SUPPLEMENTAL BID BULLETIN NO. 1

Project: Refurbishment of College of Industrial Technology Dean's Office, Male and Female Toilets, and Classrooms (ETL-3AB and Lecture Room-14)

This Bid Bulletin no. 1 is issued to clarify items and shall be an integral part of the Bidding Documents.

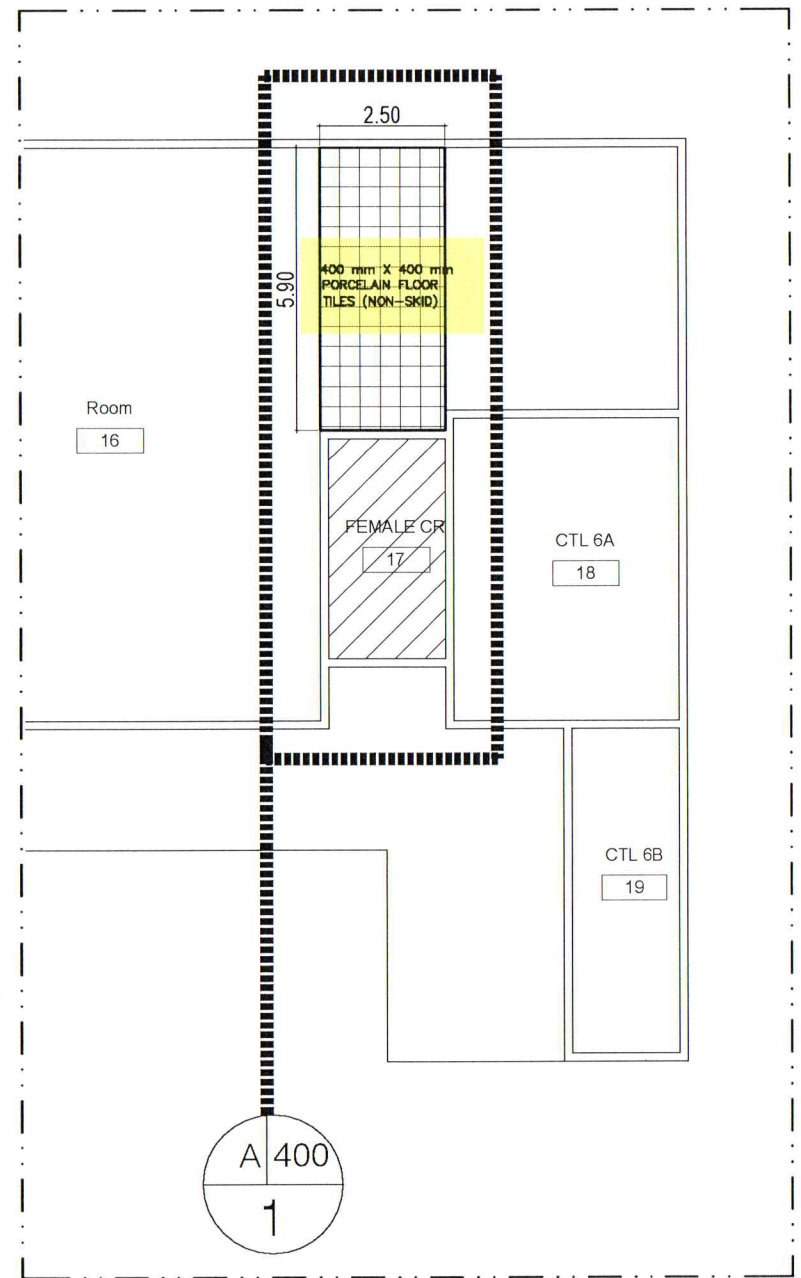
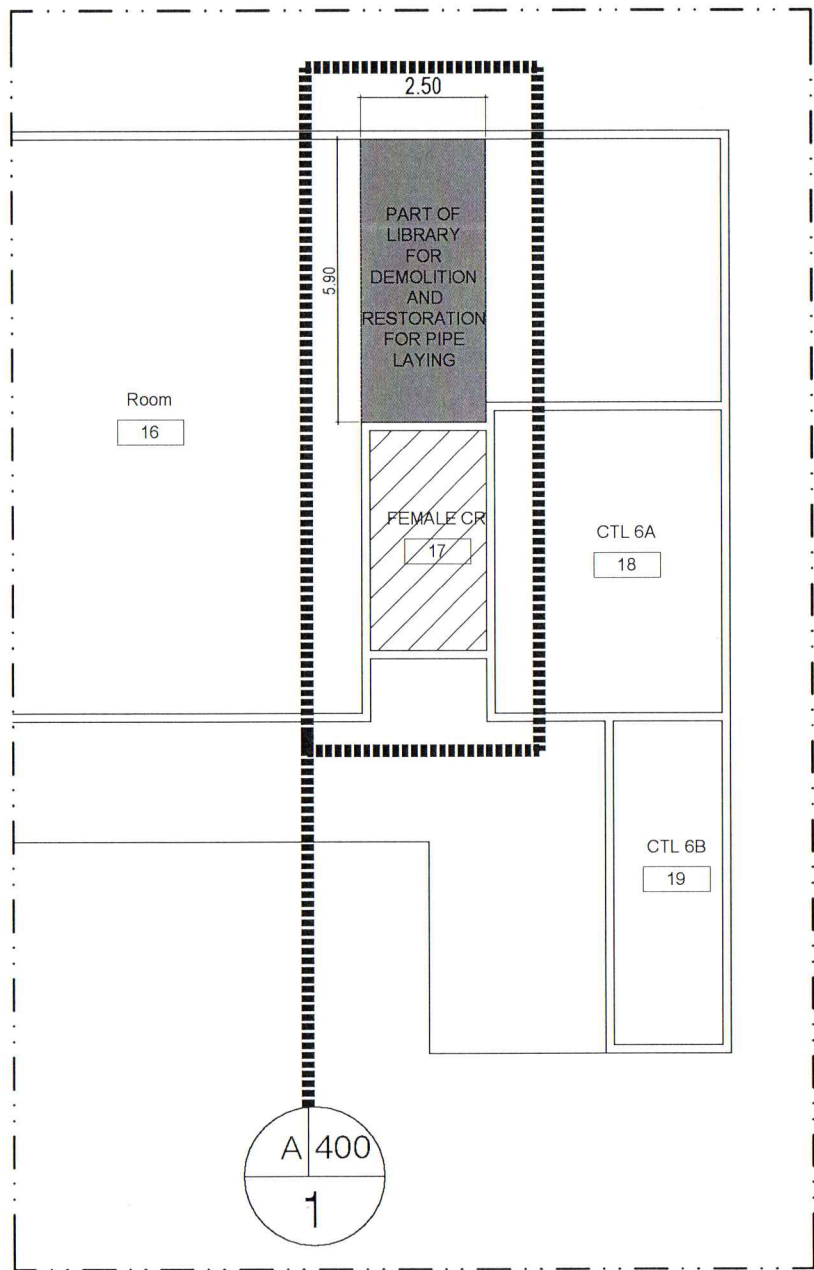
Please be informed of the modification in the bidding documents.

LECTURE ROOM 14A&14B
2 NEW CONSTRUCTION PLAN
SCALE: 1:150 MTS

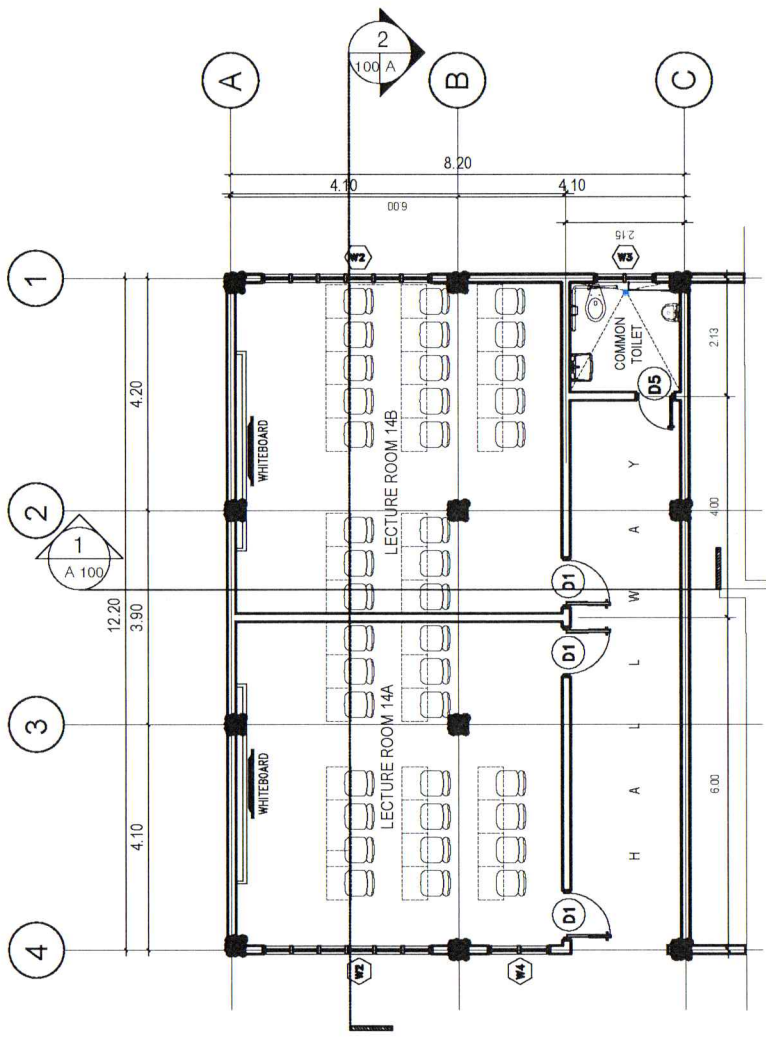
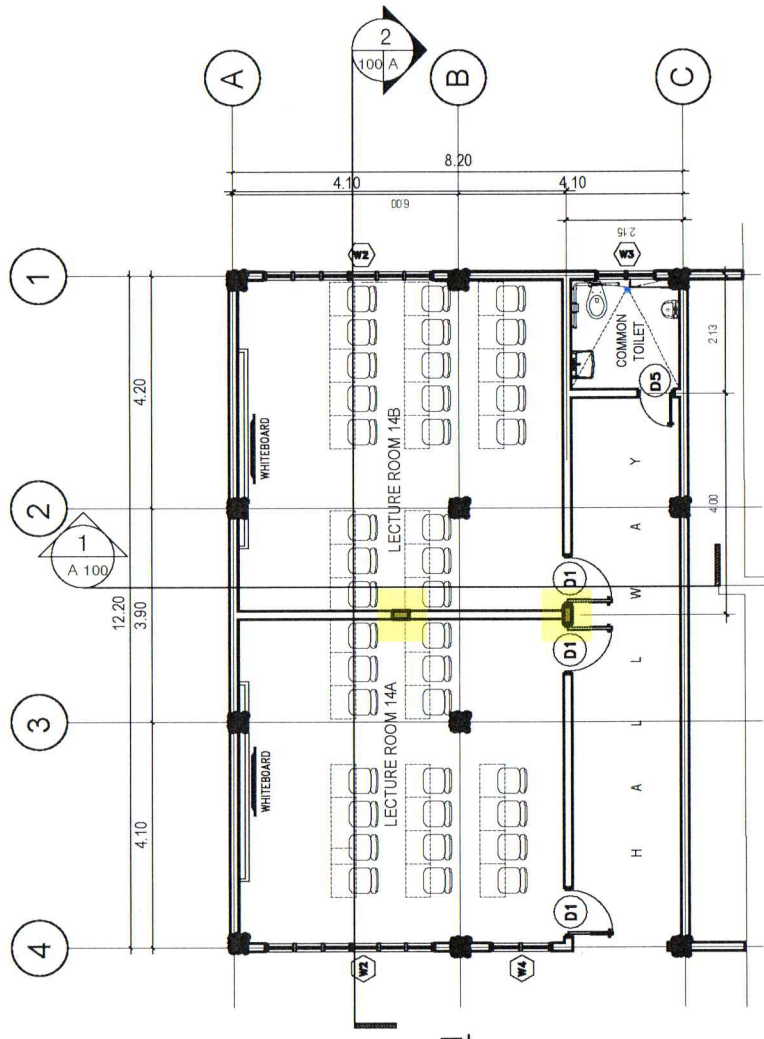
TYPICAL STIFFENER COLUMN SECTION
